Access Compliance Report

Public Rights-of-Way

(Curb Ramps)

Intersection ID: 48087	Main Street: RED_CREST_LN	Cross Street: MALLARD_GLEN_DR	Location: NW
ADA ID: F5963D52A8B5	Ramp Type: Perp	Initial Pass/Fail: Fail	Overall Compliance: No
			Severity Score: 21.25

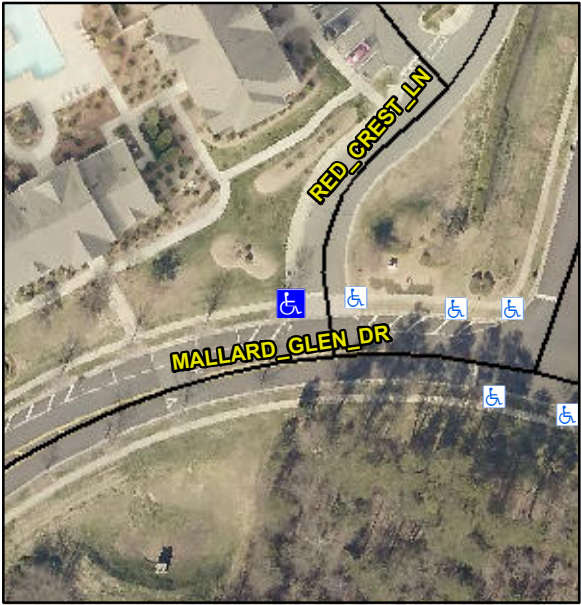
Codes/Mitigation Info/Possible Solution			Field Measurements/Component Compliance		
	Possible Solutions:		Compliance	Description	Data
	Remove & Replace Entire Ramp.		N/A	Ramp Length (in)	62.0
			No	Ramp Width (in)	46.0
			N/A	Flare Type LT	N/A
			N/A	Flare Slope LT (%)	N/A
			N/A	Flare Traversable LT?	N/A
			N/A	Landing Length (in)	N/A
			N/A	Landing Width (in)	N/A
			N/A	Landing Slope (%)	N/A
			N/A	Landing X Slope (%)	N/A
<p>Surveyor Notes:</p> <p>N/A</p> <p>PROW/ADA:</p> <p>R304.5.1, R304.2.2</p>			N/A	Flare Type RT	N/A
			N/A	Flare Slope RT (%)	N/A
			N/A	Flare Traversable RT?	N/A
			N/A	DWS Provided?	N/A
			N/A	DWS Contrast?	N/A
			N/A	DWS Length (in)	N/A
			N/A	DWS Full Width?	N/A
			N/A	DWS Offset (in)	N/A
			N/A	Shared Landing?	N/A
			N/A	Gutter Ponding?	N/A
			N/A	Gutter Lip Ht (in)	N/A
			N/A	Painted X Walk1?	No
				X Walk 1 Direction	To E
			N/A	X Walk 1 Width (in)	N/A
				X Walk 1 Slope (%)	1.0
				X Walk 1 X Slope (%)	1.8
